**ADDITIONAL PROCESS INFORMATION
(LETTERS TO DEQ, 5/31/07 AND 6/13/07)**

CONFIDENTIAL			
C 02/20/06	CLIENT REVIEW/COMMENT	QPT	CNC SDC RSC
U 11/08/07	ISSUED FOR CITY AND PROJECT CONTINUING REVIEW AND COMMENTS	QPT	CNC SDC RSC
A 10/02/07	FOR CLIENT COMMENTS	QPT	CNC SDC RSC
AS DATE	ISSUE DESCRIPTION	BY	CHKD MOD APPR
<p>THIS DOCUMENT CONTAINS PROPRIETARY INFORMATION BELONGING TO Shaw & Webster, Inc. and Hoku Materials, Inc. and is to be returned upon request. The contents may not be copied, disclosed to third parties, or used for other than the express purpose for which it has been provided without written consent of Shaw & Webster, Inc. and Hoku Materials, Inc.</p>			
		<p>HOKU MATERIALS, INC. 3500 MT/YEAR POLYSILICON PLANT POCATELLO, IDAHO</p>	
PLOT PLAN

RE: Response to Questions from Review of Hoku Materials, Inc PTC Application

Additional Vent Gas Recovery (VGR) Details

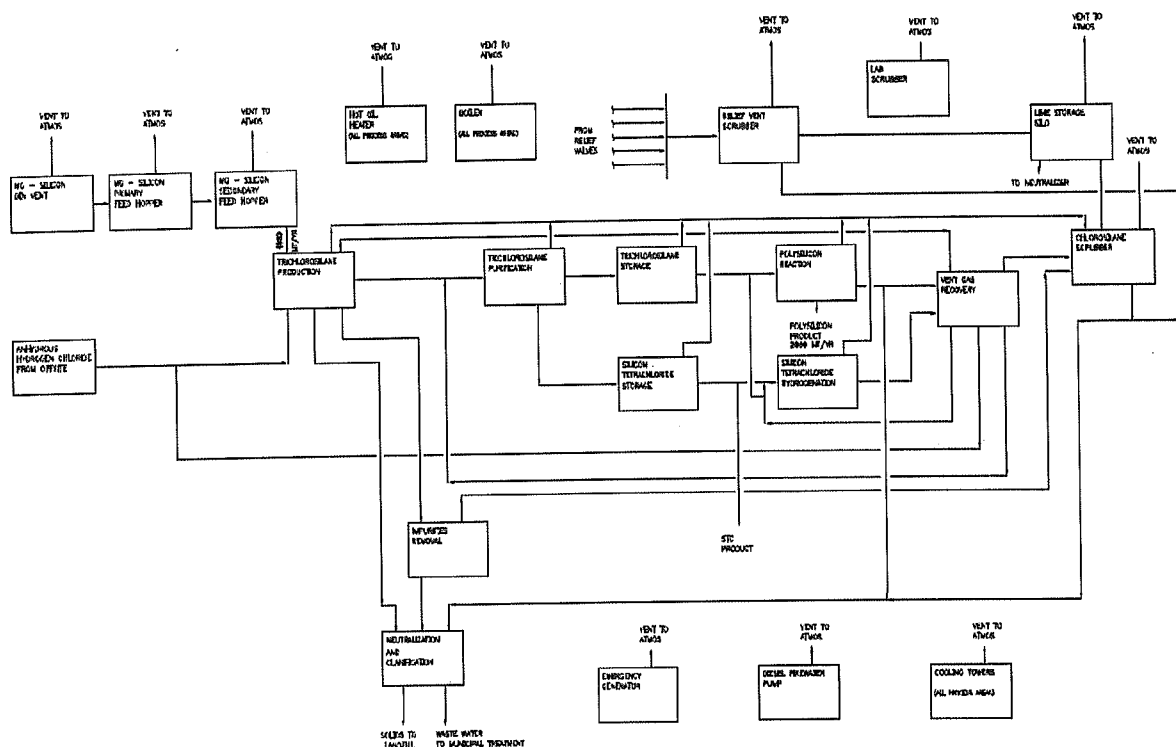
Part 1) The vent gas recovery unit is stated to remove liquid chlorosilanes, hydrogen chloride gas and hydrogen gas from the vent gas stream prior to the chlorosilane scrubber. Please describe in detail the physical and/or chemical processes that are employed to accomplish the removal of chlorosilanes and hydrogen chloride gas.

Part 2) It appears that the proper operation of the vent gas recovery unit is critical in assuring that chlorosilanes and hydrogen chloride gas is not emitted in quantities greater than what is stated in the application. How is the vent gas recovery unit operated and maintained? Please see the explanation below.

Part 3) What are the operating parameters that must be maintained to assure the vent gas recovery unit operates as designed (temperature, pressure drop, flowrates, etc.)

Part 4) If the vent gas recovery system is not critical in limiting emissions of chlorosilane and hydrogen chloride please describe how the chlorosilane scrubber is designed to abate emissions of these pollutants that would occur without the vent gas recovery system operating as designed.

Response to Part 1) There may be a misunderstanding of the operation of the vent gas system. In general, the vent gas recovery unit recycles all gases exiting from the CVD reactors (ie Siemens reactors) and hydrogenation reactors.

Response to Part 2) The Vent Gas Recovery recycles all chemicals from the reactors back into other parts of the process. It is not essential to operate the vent gas recovery unit properly to ensure that the chlorosilane and hydrogen chloride gas is not emitted. It is a recycle unit for the plant and not a pretreatment unit for the scrubbers. The unit is linked with the reactors to control the quality of materials returned/recycled. Shut down of the VGR does not mean that chlorosilanes or HCl are released. Shutdown of the VGR unit

Response to Part 4) There is no continuous flow to the vent gas scrubber from the vent gas recovery system. As such if the VGR system is down there is no additional load to the scrubber system. Hoku believes there is a misunderstanding of its process. Hopefully, the details in this response document help provide clarity. If not, please contact Karl Taft for further information.

The Vent Gas Recovery recycles all chemicals from the reactors back into other parts of the process as shown on the block flow diagram below (this is the same diagram submitted with the application on May 15, 2006).

There are no continuous vents from the VGR to the scrubbers. VGR uses typical processing equipment including distillation columns, reboilers, condenser, heat exchangers, pumps, compressors and absorbers to separate the various chemicals for re-use in the process. A more detailed description of the VGR unit is below.
